# Staff Report

**To:** Salt Lake City Historic Landmark Commission  
**From:** Sara Javoronok, AICP, Senior Planner, [sara.javoronok@slcgov.com](mailto:sara.javoronok@slcgov.com), 801-535-7625  
**Date:** October 5, 2023  
**Re:** PLNHLC2023-00335 – 258 North J Street

## Minor Alteration

*South elevation view of tree platform*

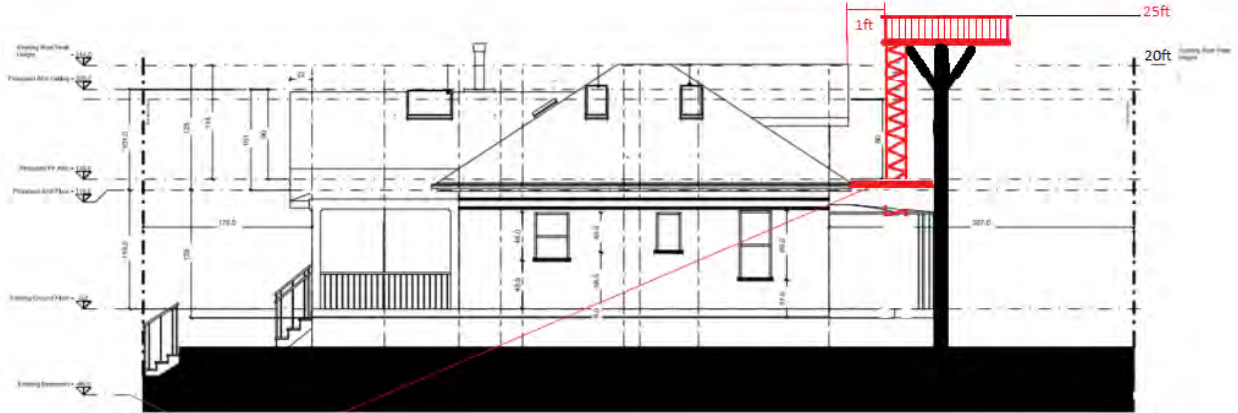
Platform: 12x10 / 120 sq ft  
Platform height: 22 ft which is 2ft above 20 ft roof  
Platform frame: 2x8 treated cedar  
Railing: vertical spindles, same as house and neighbors  
Total deck height with 3ft railing is 25 ft

*Site plan*

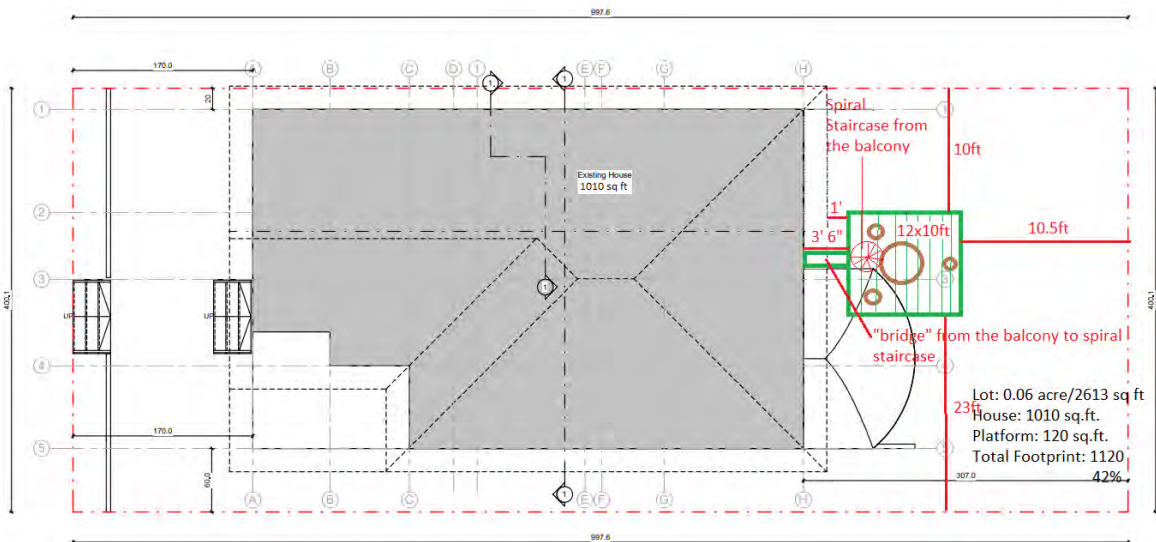
The platform would be 1' from the eaves on the rear of the dwelling and the eaves extend 2'6" from the rear façade. The applicant is requesting a modification of 6" from the required 4' to 3'6" for the distance of the structure from the rear façade. The platform and railing would extend 5' above the peak of the roof. Access would be via a bridge and spiral staircase.

The site plan shows the reduced tree platform. As identified above, the platform would be 3'6" from the rear façade of the building. The applicant is also requesting a modification to the maximum building coverage of 1.5%. See the Key Considerations and Attachment E for additional information.
